Project XP55		Product Name: Replacement rudder		Filename XP55 replacement rudder	
 JEFA MARINE A/S NIMBUSVEJ 2 2670 GREVE. DENMARK Tlf: +45 4615 5210 Email: info@jefa.dk www.jefa.dk		Drawing no. -	Sheet: 1 of 1	Proj. method: 	
		Material: Alu 6082	Scale: 1:15	Format: A4	CAD-System: SolidWorks
Creation Date: 10-03-2023		Dimensions are given in mm. Dimensions without tolerances according to DS/ISO 2768-m.			
Author: Thor		This drawing belongs to Jefa Marine A/S and may not be used or shown without permission.

RUD55

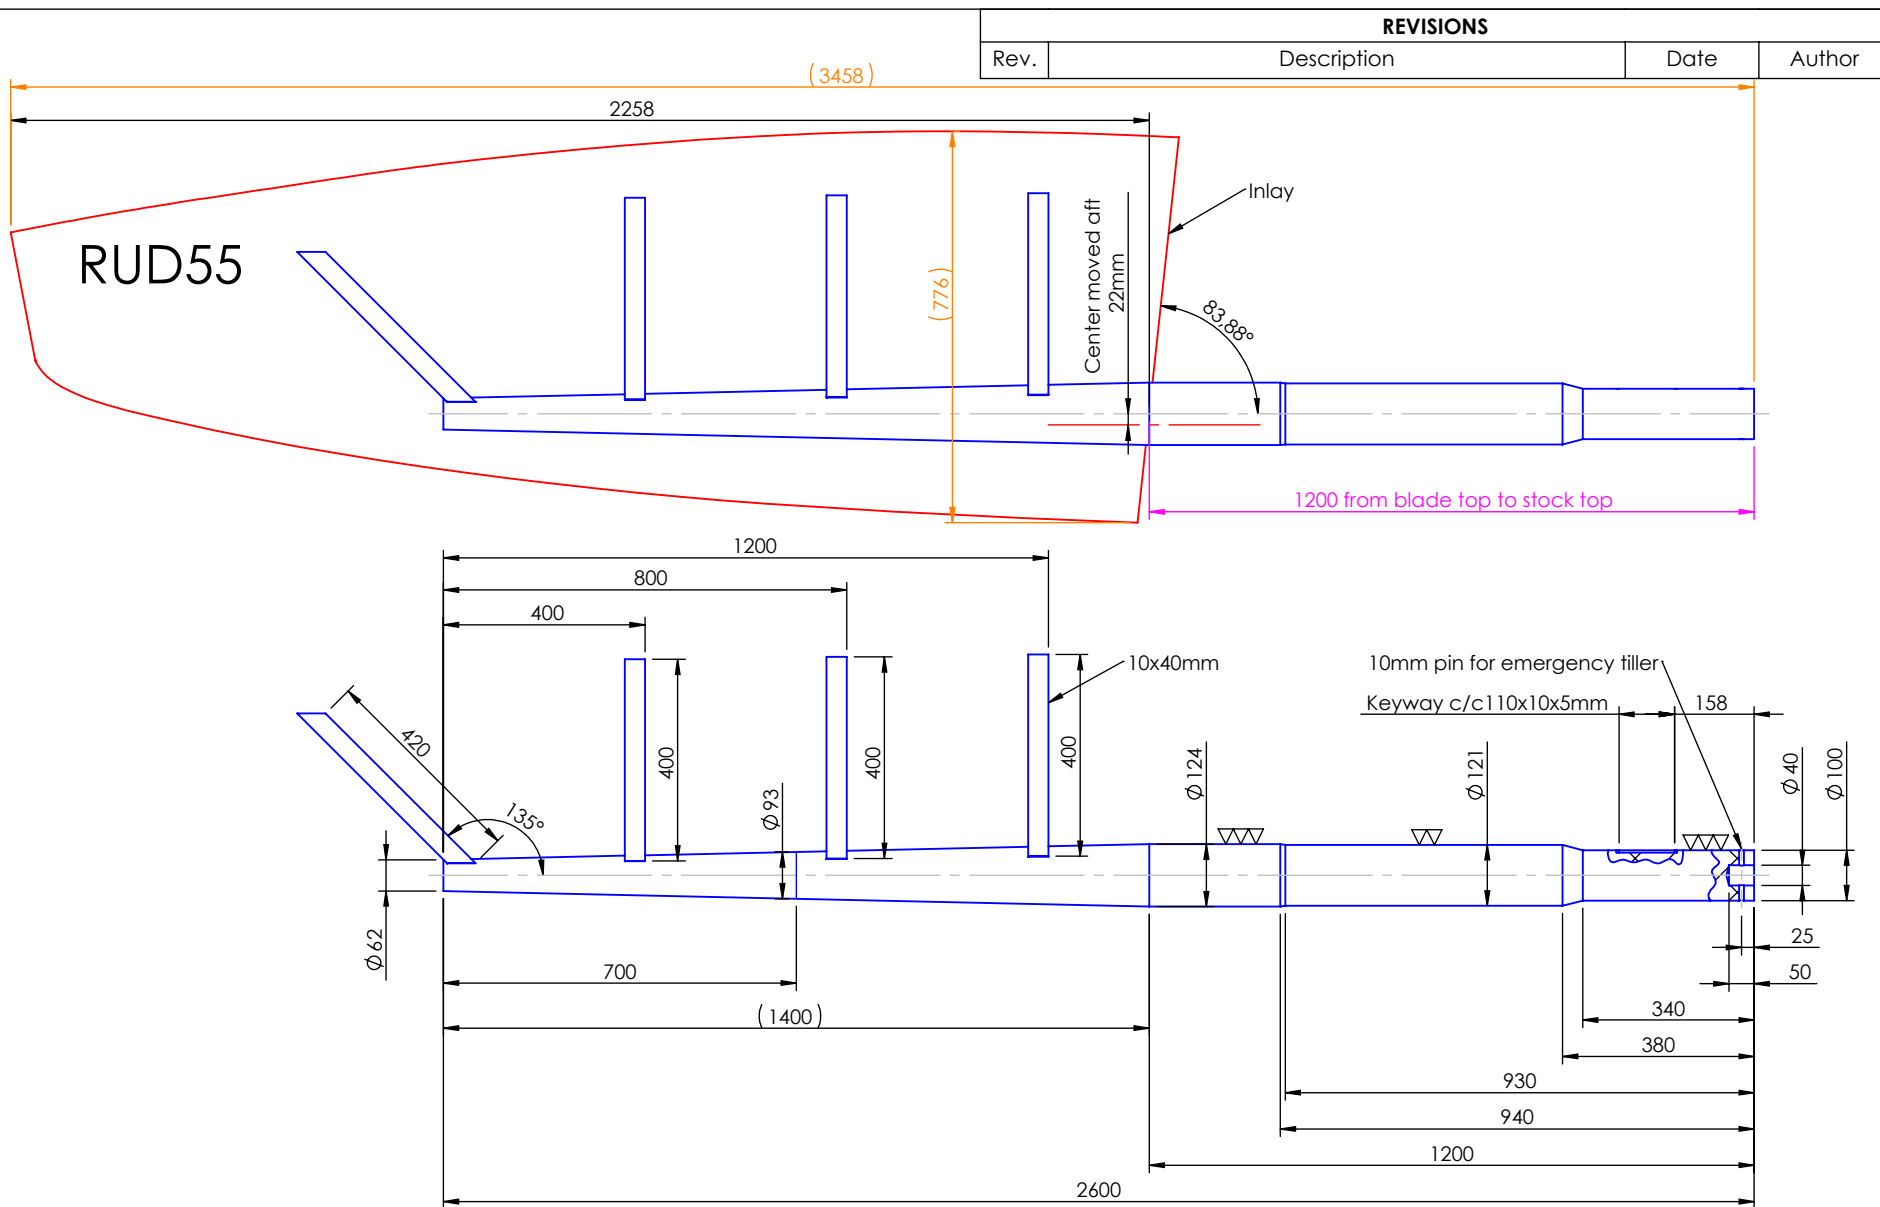
Stock moved 22mm aft from original axis on RUD55, to give a blance of 19,9%
